FIRE SAFETY INSPECTION REPORT

Tanima Knit Composite Ltd. (Extension)

Inspected by: Md. Rakibul Alam and Md. Anisuzzaman

Date: 10 Oct 2022

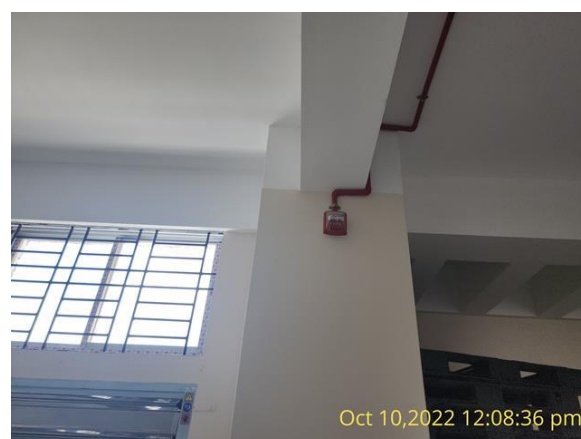
F-2	Fire Protection	The firefighting system (standpipe system) installation requires detailed review to conform compliance with NFPA 14. (Both Building).	Submit as built drawing, testing records, equipment certification and all relevant documents to the RSC for review, approval and then acceptance test.	Within 2 months

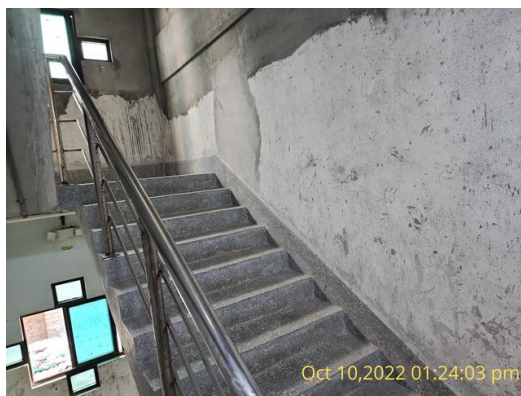
F-5	Egress Lighting	Exit signage was not provided at several exits / along the path of egress / in a readily visible location. (Building 7)	Provide exit signs above all building exits to the exterior, all doors to the exit stairs and along all paths of travel where a change of direction is not obvious.	Within 1 month
F-6	Egress	Handrails are not provided on both sides of both exit stairs. (Building 8)	Provide handrails on both sides of the exit stair. New handrails shall have a minimum height of 865 mm (34 in.) and a maximum height of 965 mm (38 in.) as measured from the leading edge of the tread. Intermediate handrails shall be provided when the stair width exceeds 2.2 m (87 in.) Handrail height shall be 34 in to 38 in as per RSC 6.12.1.2.	Within 2 months

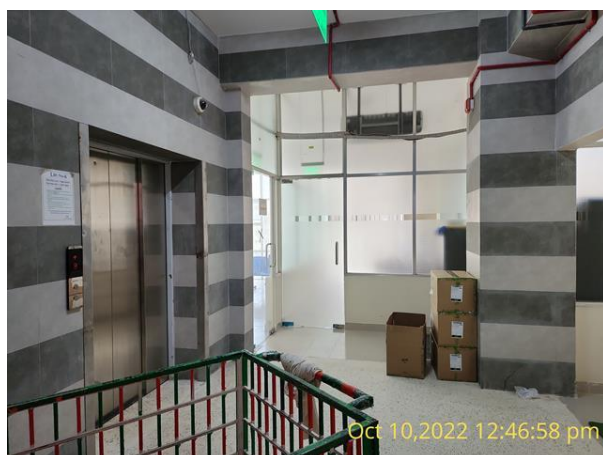
F-10	Fire Rated Construction	Elevator shaft opening in the factory floor without fire separated. (Building 7)	Separate all elevator shaft from work areas and other building spaces on all floor levels by minimum 2- hr fire-rated construction. Provide minimum 1.5- hr fire rated doors/lift landing doors to maintain the fire fire separation from floor and exit enclosures.	Within 3 months
------	-------------------------	--	--	-----------------

Ensure that all fire doors are self-closing and positive latching, and are provided with fire exit (panic) hardware where serving production floors or assembly occupancies (if applicable).

If fire doors are required to be held open for functional reasons, provide automatic-closing devices tied to the fire alarm system.

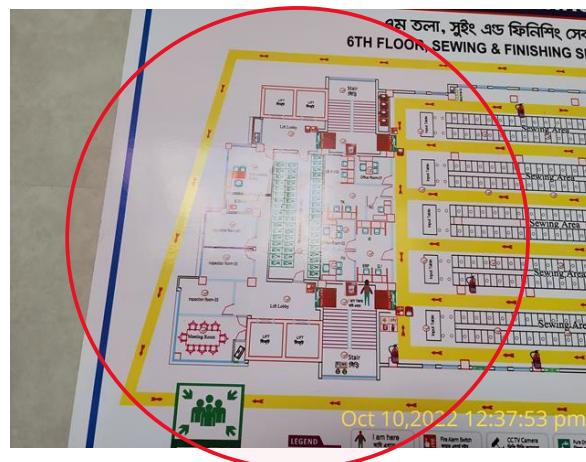
F-13	Egress	A single means of egress is provided from north portion at the building-7. The building has 4 exits however floor layout and partition creates single exit scenario.	Ground or basement story is allowed a maximum of 50 occupants and 23 m (75ft) travel distance. The second story is allowed a maximum of 30 occupants and 23 m (75ft) travel distance. All other stories require a minimum of 2 egress exits. Reconfigure the egress arrangement of building-7 to meet the above requirements.	Within 3 months
------	--------	--	---	-----------------
